SUBJECT: Closure of an unnamed alley between Twentieth St and Twenty Second St
MPC File # 12-A-14-AC; City Block 10582

**Re: Right-of-Way Closure Request 12-A-14-AC
Block No. 10582
CLT No. 108
Parcel No. 13**

File No. 12-A-14-AC

Closure of Unnamed Alley

Electric

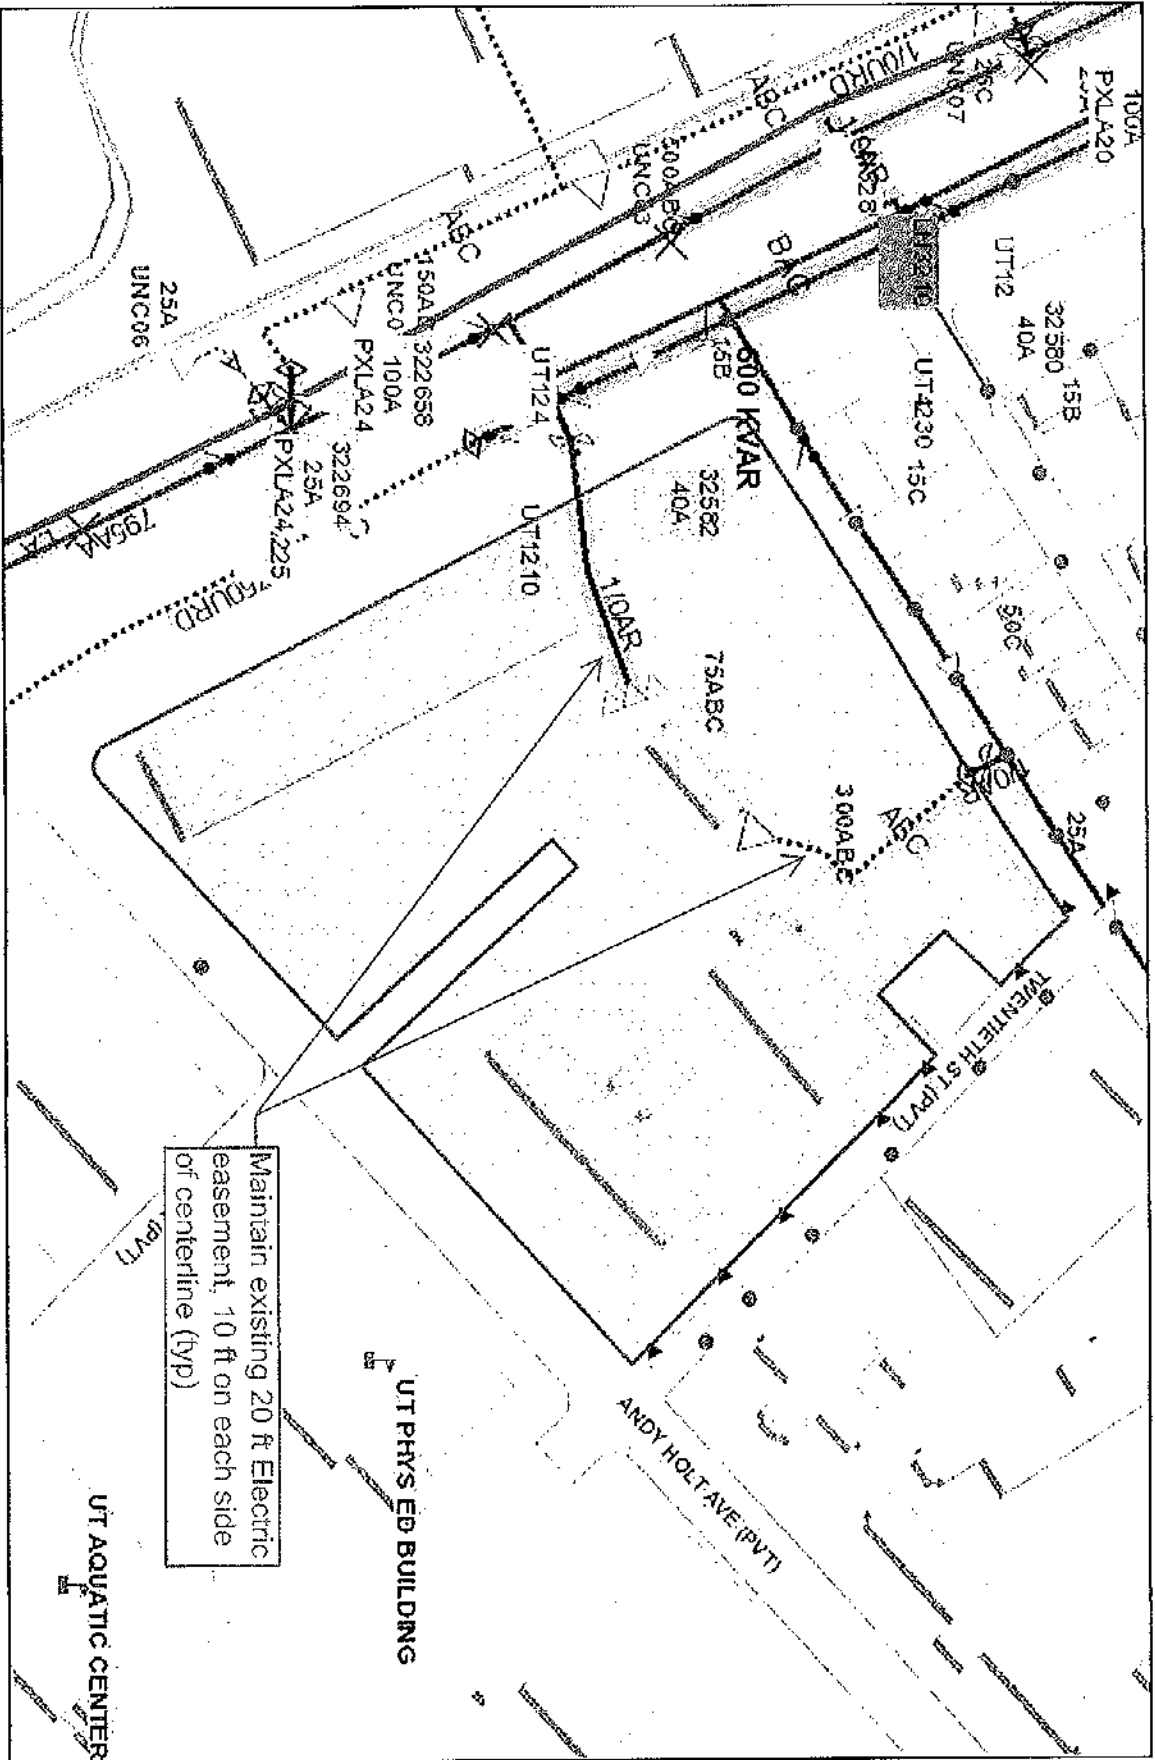
We have reviewed our records and find that we have existing utility facilities located within the subject right-of-way. The approximate location of these facilities is indicated on the enclosed prints. However, KUB does not release and hereby retains all easements and rights for existing utility facilities, whether or not shown on these prints.

Should this right-of-way be closed, KUB will require the following permanent easement for its utility facility.

Electric – 10 feet on each side of the centerline of the electric line – 20
Sewer – 7.5 feet on each side of the centerline of the wastewater line, 15 feet total width

File No. 12-A-14-AC Closure of Unnamed Alley Sewer
Between 20th and 22nd St

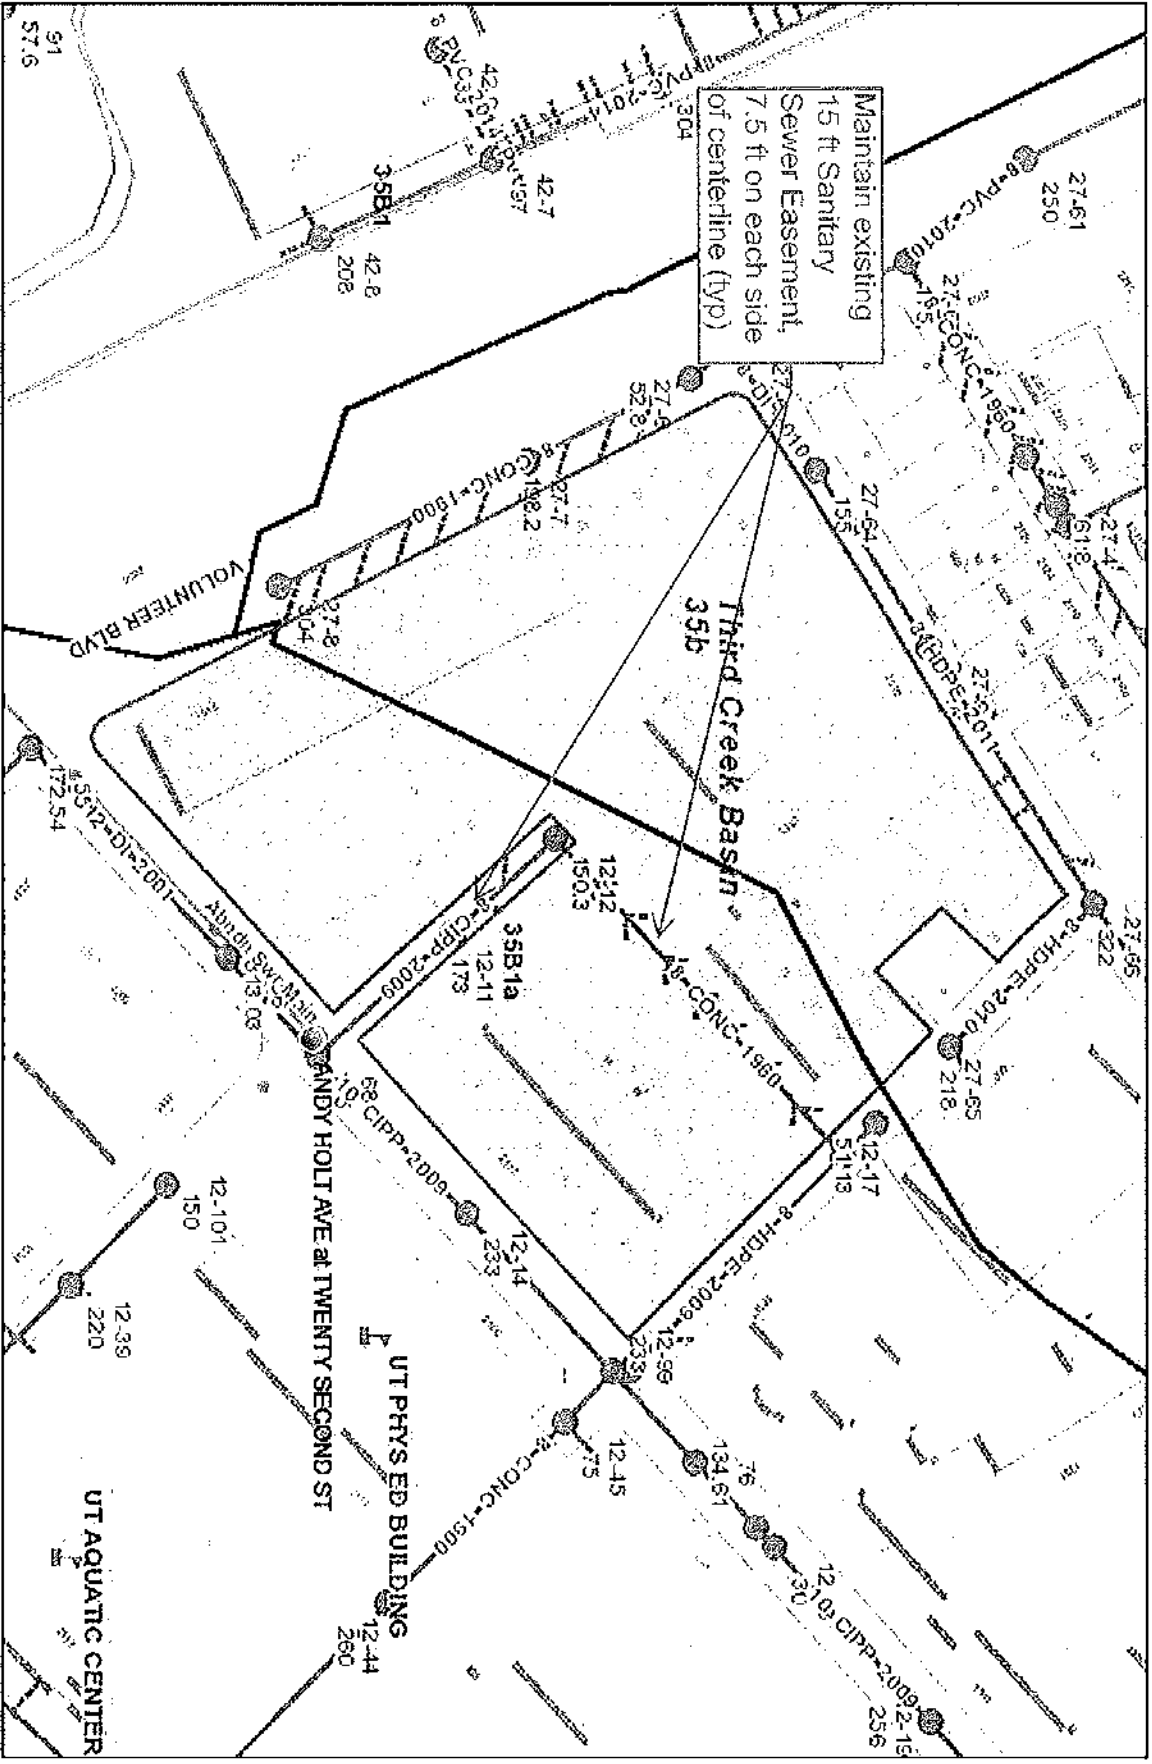
Maintain existing
15 ft Sanitary
Sewer Easement,
7.5 ft on each side
of centerline (typ)
